CHANGE BULLETIN 06

F.G.A. No. 21003

ROOMS TO GO – OFFICE RENOVATION & EXPANSION

June 12, 2023

SHEET NUMBER
 E2.10B

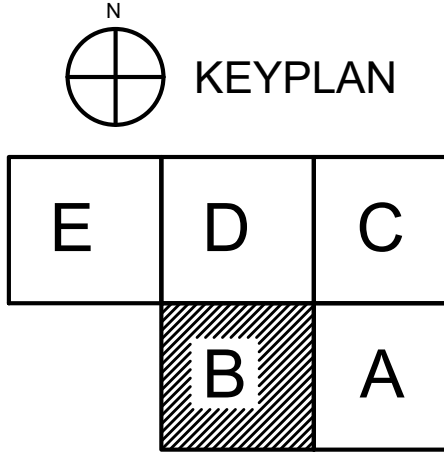
- Add note for fan tie-in to timer switch for room being served by fan.
- Item 14: Refer to Sheet E2.10B – Lighting Plan B
- Add wall back to HR Office B153.

- Shifted lighting in HR Office B153 due to wall addition and shift.
 - Added type “EM” in adjacent corridor due to wall addition.
- Item 15: Refer to Sheet E6.00 – Electrical Schedules – Service One
